Memorandum

DOCKET 09-AFC-8

Subject: **ENERGY COMMISSION STAFF'S REBUTTAL TESTIMONY
GENESIS SOLAR ENERGY PROJECT (09-AFC-8)**

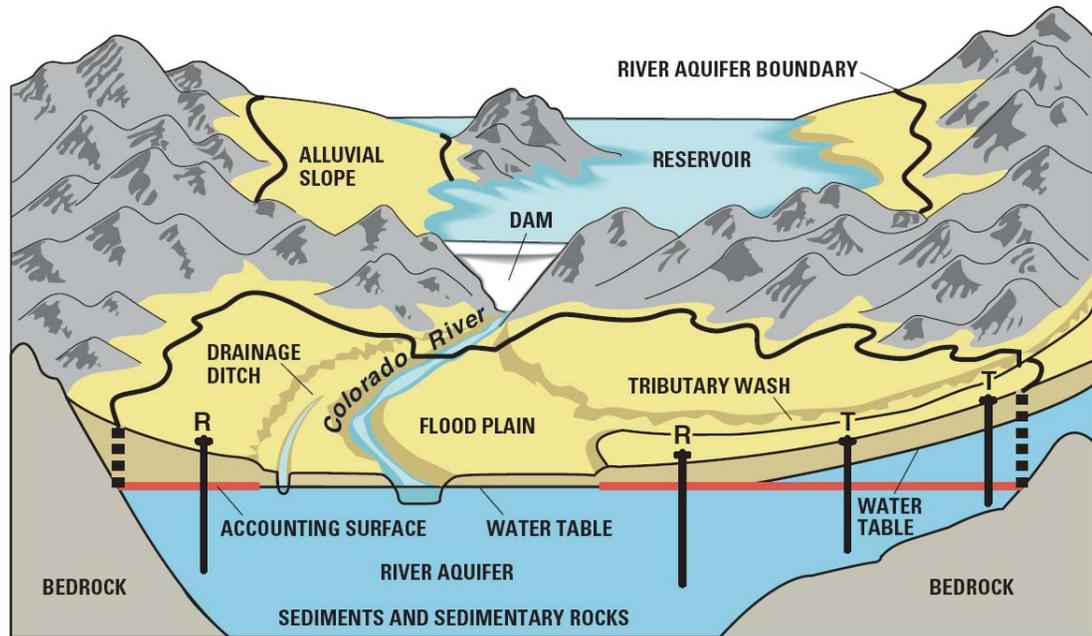
- b. The project's use of groundwater will have no measurable effect on surface waters of the Colorado River, and will not reduce supplies available to Colorado River surface water users.

Response: The legal framework for apportionment of waters of the Colorado River was originally set forth in the Colorado River Compact of 1922. Water in the lower Colorado River is apportioned among the States of California, Arizona, and Nevada by the Boulder Canyon Project Act of December 21, 1928 (U.S. Congress, 1948, p. A213–A225) and was confirmed in 2006 in the Consolidated Decree (U.S. Supreme Court, 2006) after the Blythe II Commission hearing. The Consolidated Decree is specific about the responsibility of the Secretary of the Interior to account for consumptive use of water from the mainstream. Consumptive use is defined to include “water drawn from the mainstream by underground pumping.” In 2008, the USGS (Wiele et al., 2008) prepared a report titled “Update of the Accounting Surface Along the Lower Colorado River.” As part of that analysis they clearly demonstrated that the “river aquifer” as stated in the 2006 Supreme Court decree extends into the tributary washes of the Colorado River as diagramed here:

That concept is clearly indicated in the above figure and in Figure 6 below. The concept of distance from the Colorado River had no bearing on whether the underlying groundwater was indicated as part of the “river aquifer.”
